Laney

Service Diagrams

DRAWN	DEH
DATE	11/06/98
TITLE	TUBE FUSION TF200
DRW. NO.	9301_3

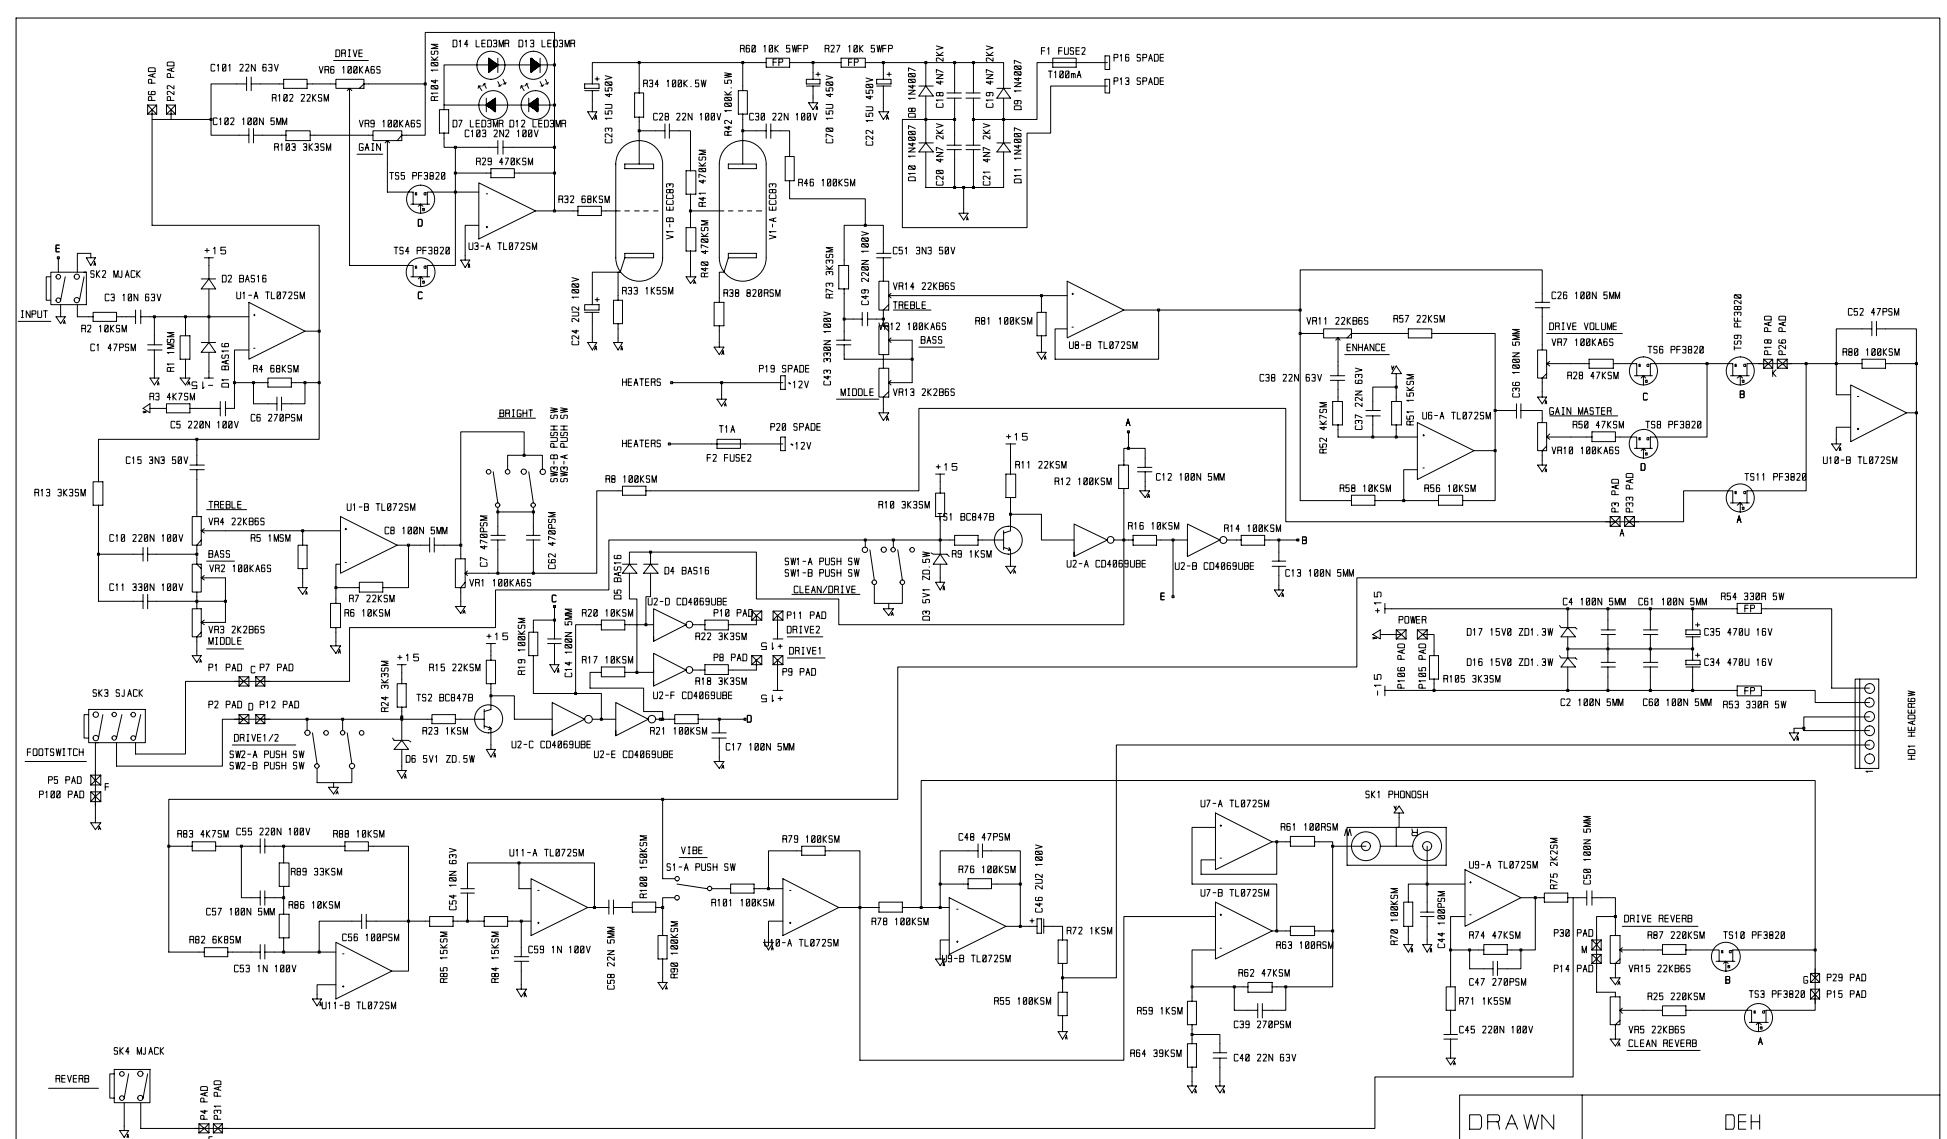
ISSUE	BOARD ISSUE 2 TO 3
TYPE	BRIGHT FREQUENCY ADJUSTED SEE CHANGE NOTE 158 26/06/98

DRAWN	DEH
DATE	11/06/98
TITLE	TUBE FUSION TF200
DRW. NO.	9301

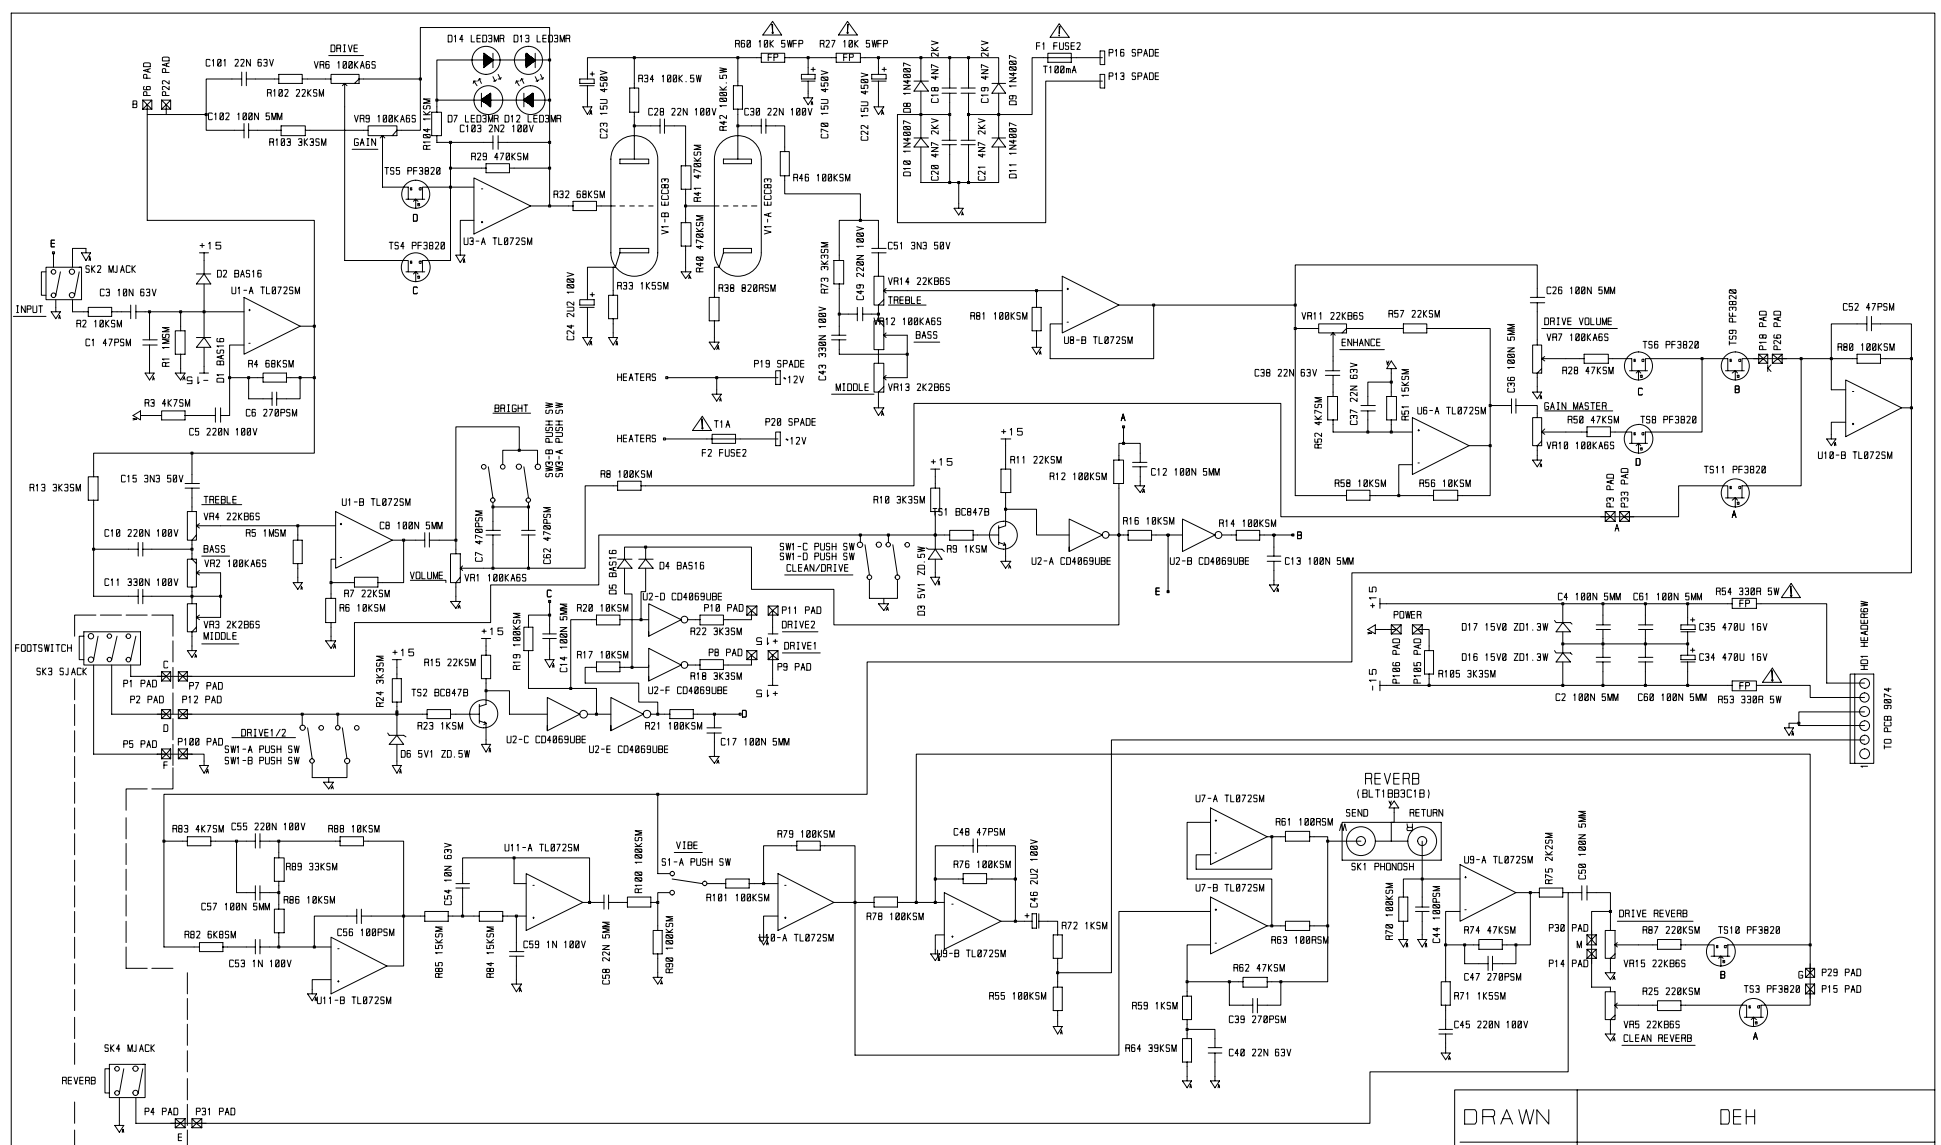
ISSUE	BOARD ISSUE 3	ISSUE 3
TYPE	BRIGHT FREQUENCY ADJUSTED SEE CHANGE NOTE 159 26/06/98	R104 CHANGED FROM 10K TO 1K. SEE CHANGE NOTE 172 27/8/98
